DIVISION OF WATER RIGHTS

In the matter of: **Gay Ditch Co.**

**NOTICE OF PARTIAL
COMPLIANCE**

SEAA No. 1325

GAY DITCH FLUME

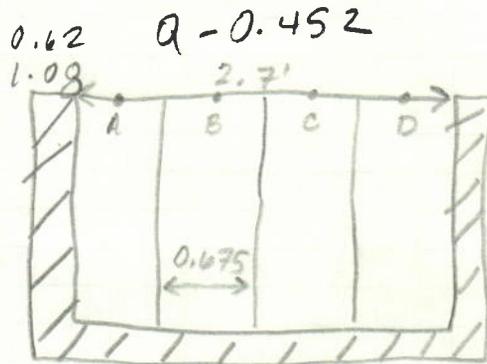
FLUME - 2.8 cfs.

A - 0.34'
H_A - 0.82
V_A - 1.18 ft/s.
Q_A - 0.653

B - 1.01'
H_B - 0.82
V_B - 1.56
Q_B - 0.863

C - 1.69'
H_C - 0.8
V_C - 1.24
Q_C - 0.670

D - 2.36'
H_D - 0.78
V_D - 0.99
Q_D - 0.521

Q_T = 2.71
